## **Determination 2018/055**

### **Regarding the compliance of a warehouse fitout, comprising of a storage racking system and a mezzanine floor, with the fire safety requirements of the Building Code at 49 Stoneleigh Drive, Rolleston**

**Figure 2: Floor plan of racking system and mezzanine level (not to scale)**

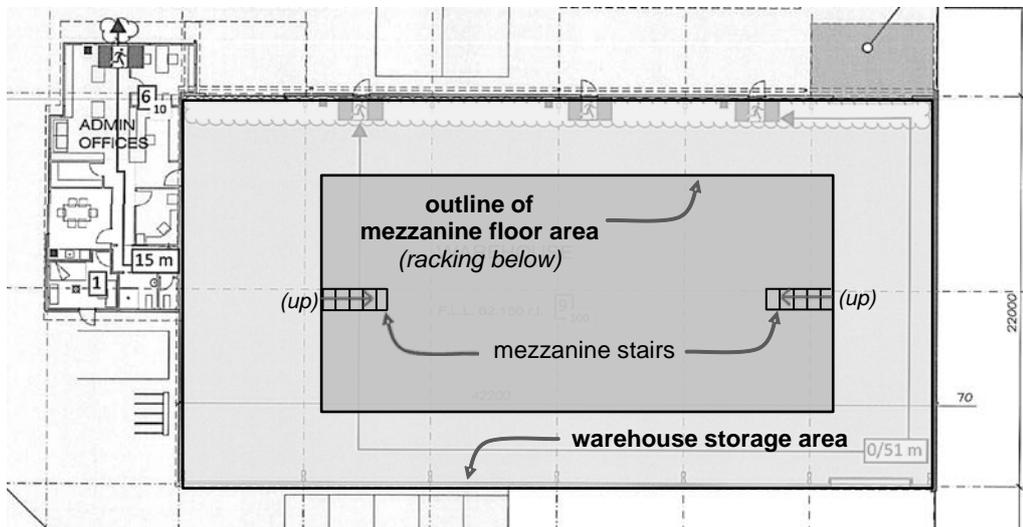
- the mezzanine floor area, at 452m<sup>2</sup>, is well above the maximum for intermediate floors of 35m<sup>2</sup> (considering the building as a warehouse with storage higher than 3m<sup>13</sup>)
- the mezzanine's construction and supports (i.e. particle board flooring on a light steel frame system) do not achieve the minimum required fire resistance rating of 30/30/30 and 30/-/- respectively, and
- more exit signs are needed throughout the building to indicate escape routes through the racking system.

- 6.7 I also note, that there appear some valid concerns raised both by FENZ and the experts that need addressing; the large size of the mezzanine and the fire rating of its flooring (particle board) and support frame. There is increased risk associated with the significant departure in size of the mezzanine in comparison with the Acceptable Solution. While the building code is performance based and the proposed mezzanine size is not specifically prohibited, I would expect to see design features that address or mitigate this increased risk.
- 6.8 I also note, the travel distance measurement that is provided by the applicant to determine the total open path available commences at the mid-point of the mezzanine. In my view, this does not provide a worst case travel distance that would occur for an occupant at one end of the mezzanine yet unable to use the closest exit.

- the period of structural adequacy of the mezzanine's steel support in the event of a fire does not comply with Clauses C4.3, C5.6 and C6.3, and
  - the fire rating of the mezzanine floor does not comply with Clauses C4.3, C5.6 and C6.3.

**Figure 3: The racking system and mezzanine level (not to scale)**

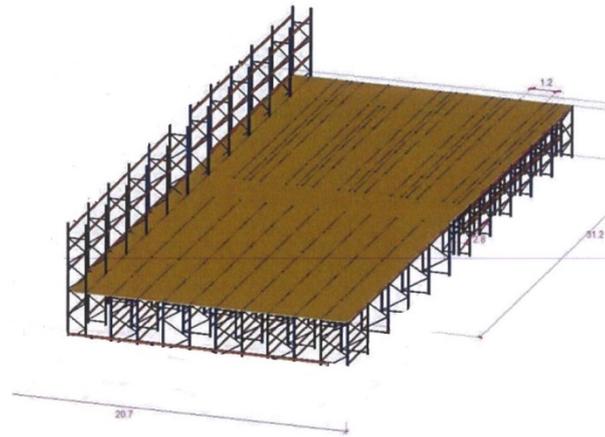
- the inherent fire resistance of the mezzanine flooring and supporting system using AS 1720.4<sup>11</sup> is not considered adequate to comply with Clauses C4.3 and C5.6 (the experts noted this standard is applicable to timber, and a number of timber products, but not to particle board, which the mezzanine floor is constructed of)

- there is a lack of information demonstrating compliance for smoke control within the warehouse as a consequence of the extended mezzanine floor
  - there is a lack of information demonstrating compliance with the requirements for firefighting access and operations.
